Memo

To: Kaitlyn McGlade (NDMNRF)
From: Kayla Mimms (NRSI)
Date: April 4, 2022
Re: Nation Rise Wind Farm: Mortality Monitoring Turbine Subset Selection

EEMP Turbine Subset Selection

Map 1
Mortality Monitoring Turbines

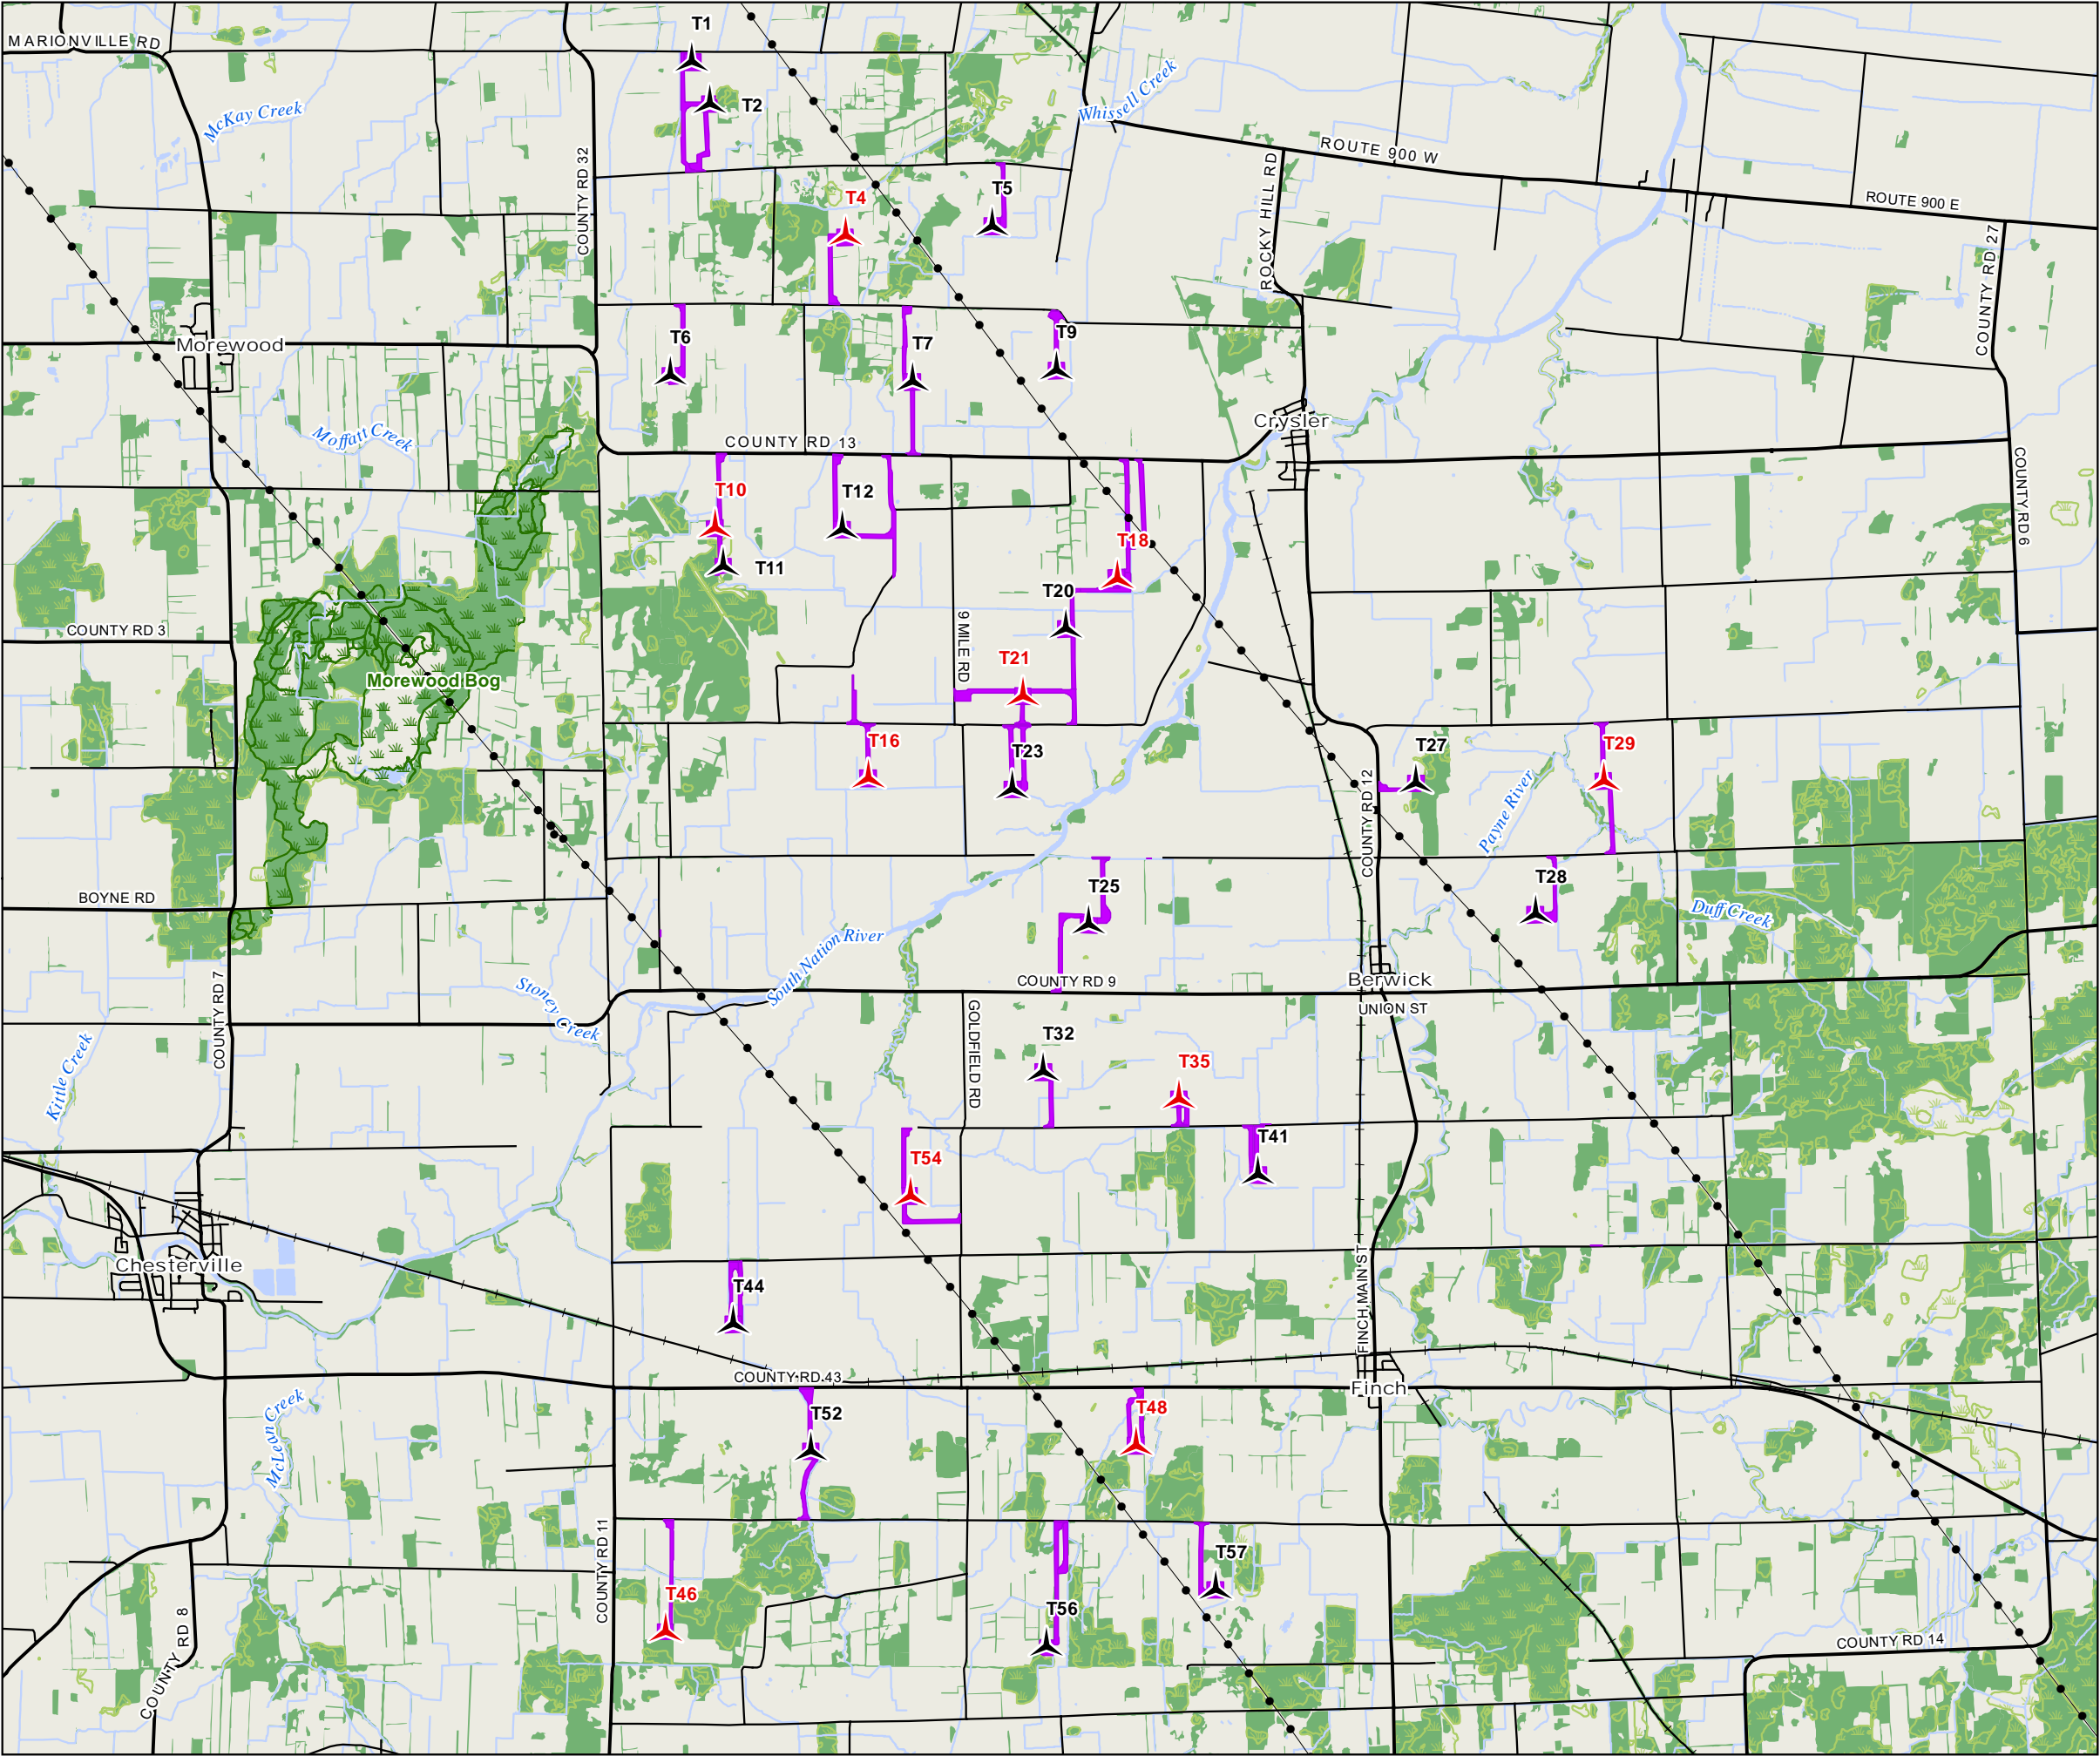
In accordance with provincial guidelines, the 10 turbines selected for post-construction bird and bat mortality monitoring must consider factors such as geographic representation, proximity to natural features, and proximity to Significant Wildlife Habitats. In consideration of the constructed layout and other site-specific conditions, NRSI has used these selection criteria to make proposed revisions to the turbine subset selection that was presented in the EEMP, as summarized in the table below and shown on Map 1.

Original Subset	New Monitoring Subset	Rationale
T04	T04	<ul style="list-style-type: none">No change
T10	T10	<ul style="list-style-type: none">No change
---	T16	<ul style="list-style-type: none">Added; similar geography to T58, which wasn't constructed
T18	T18	<ul style="list-style-type: none">No change
---	T21	<ul style="list-style-type: none">Added; similar geography to T25, which is no longer proposed in the subset

Original Subset	New Monitoring Subset	Rationale
T25	---	<ul style="list-style-type: none"> • Removed; not a preferred turbine for regular searches
T27	---	<ul style="list-style-type: none"> • Removed; not a preferred turbine for regular searches
---	T29	<ul style="list-style-type: none"> • Added; similar geography to T27, which is no longer proposed in the subset
---	T35	<ul style="list-style-type: none"> • Added; similar geography to T43, which wasn't constructed
T43	---	<ul style="list-style-type: none"> • Removed; not constructed
T46	T46	<ul style="list-style-type: none"> • No change
---	T48	<ul style="list-style-type: none"> • Added; nearby to a similar Significant Wildlife Habitat as T27, which is not a preferred turbine
T54	T54	<ul style="list-style-type: none"> • No change
T57	---	<ul style="list-style-type: none"> • Removed; near a habitat that was confirmed <u>not</u> Significant Wildlife Habitat

T58	---	<ul style="list-style-type: none"> • Removed; not constructed

Despite minor changes to the subset that was approved in the EEMP, the revised monitoring subset has been selected to maintain similar geographic representation across the Project, similar proximity to landscape features (e.g., wooded habitat, open agriculture, etc.), and similar proximity to Significant Wildlife Habitats, as compared with the subset selection that was initially provided in the approved EEMP.

After reviewing the attached map and selected turbine subset, NRSI requests confirmation from the NDMNRF regarding the chosen EEMP subset.
